NL-13-097  
July 1, 2013

Re: New York State Department of State File # F-2012-1028  
Consistency Certification for Entergy Nuclear Indian Point 2 and Entergy Nuclear Indian  
Point 3 License Renewal Application

# **Generic Environmental Impact Statement for License Renewal of Nuclear Plants**

### **Final Report Supplemental Report and Comment Responses**

**Figure 4-3. Percentage of entrainment composed of RIS fish and total identified fish relative to the estimated total entrainment at IP2 and IP3 combined (data from Entergy 2007b)**

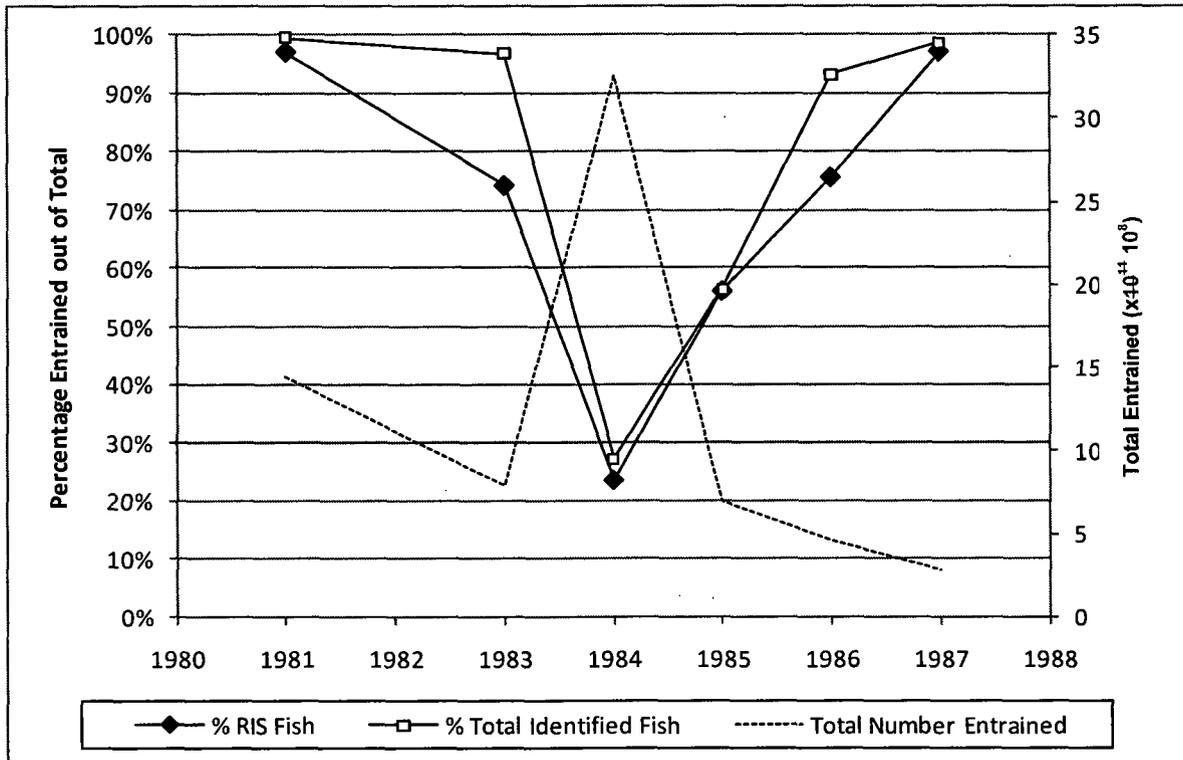
In the FSEIS, the NRC staff estimated the number entrained for a given week as the product of the mean density entrained and the combined weekly flow for IP2 and IP3. The error in the entrainment catch density directly affects Figure 4–3 in Section 4.1.2, and the error is repeated in Figure H–5 in Appendix H. In these figures, the total number entrained on the right axis should be in units of numbers  $\times 10^8$  instead of numbers  $\times 10^{11}$ . The corrected Figures 4–3 and H–5 appear below. In addition, these changes affect two portions of text in the FSEIS.

**Figure 4–3 on page 4-15** in the FSEIS is corrected as follows:

Figure H-5. Percentage of entrainment composed of RIS fish and total identified fish relative to the estimated total entrainment at IP2 and IP3 combined (data from Entergy 2007b)

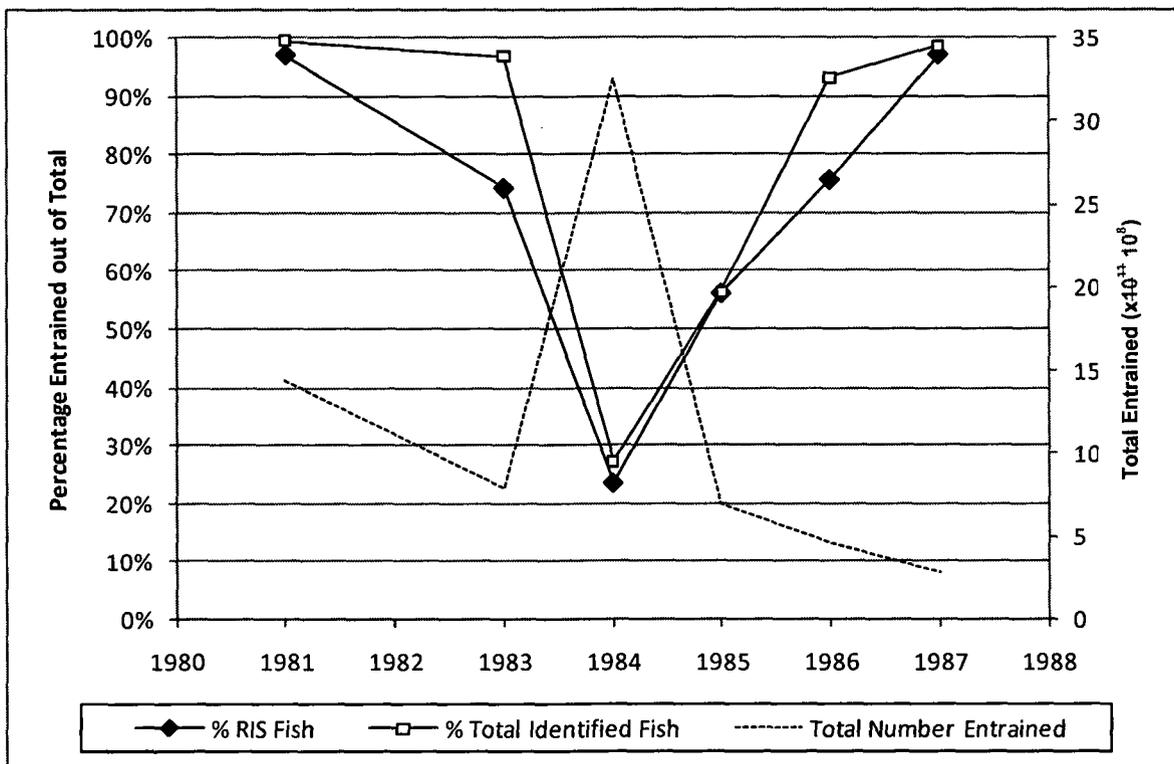
Figure H-5 on page H-23 in the FSEIS is identical to Figure 4-3 in the FSEIS and is corrected as follows:
